Oxfordshire County Council (OCC) submitted a planning application (R3.0138/21) for the Housing Infrastructure Fund 1 (HIF1) as follows:

This response has been prepared to the comments received from the Harwell Campus Bicycle Group (HarBUG) to the HIF1 planning application. HarBUG extracts are shown in italics and OCC HIF1 team responses are provided in coloured text underneath each of the main comments.

Figure 4.2: A4130 Widening - Proposed Layout

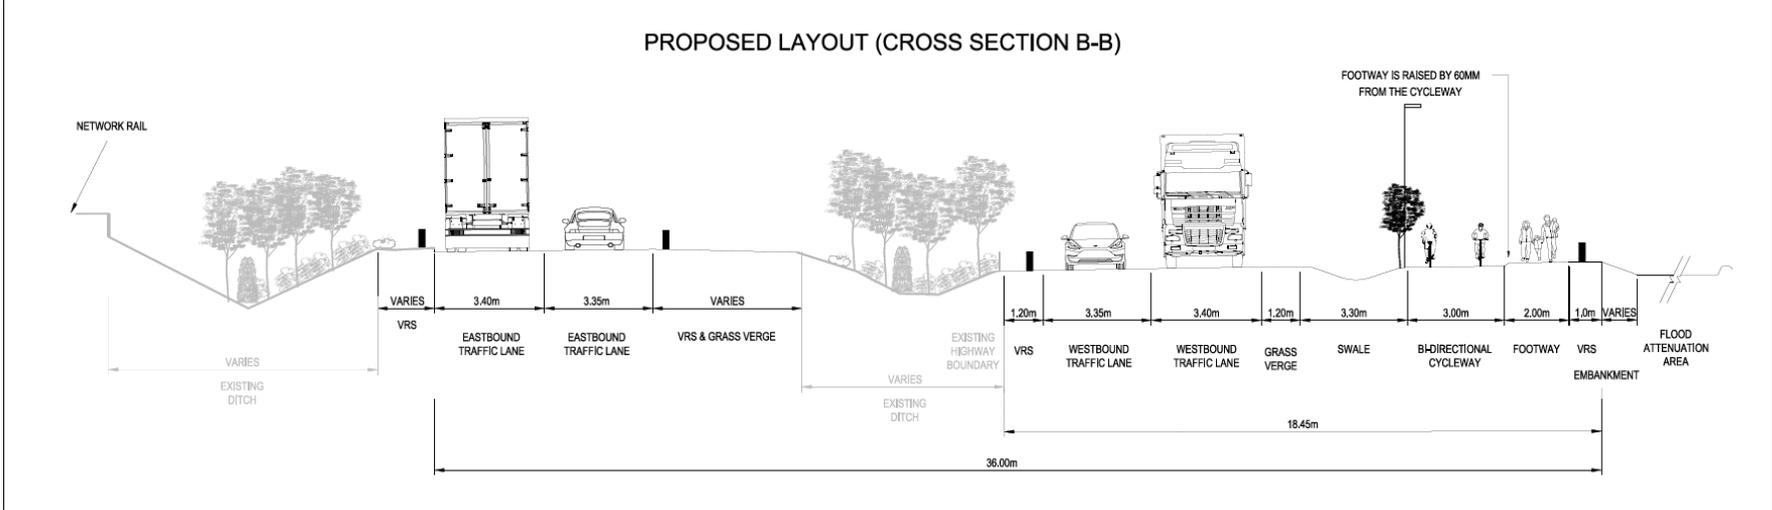
c. Will there be a clear / physical segregation between footway and cycleway i.e., not just a white line?

Please see extract from the submitted Transport Assessment (TA)

“4.2.9 An indicative cross section for the A4130 widening scheme is presented in Figure 4.2 below.

4.2.10 Figure 4.2 shows that the proposed A4130 widening scheme includes a 3m wide bi-directional cycleway and a 2m wide footway which is raised 60mm above the cycleway. There is a grass verge and swale area separating the bi-directional cycleway from the highway creating a more pleasant environment for NMUs. The GA plans listed in paragraph 4.1.2 show how it is proposed to maintain pedestrian and cycle priority across side roads”.
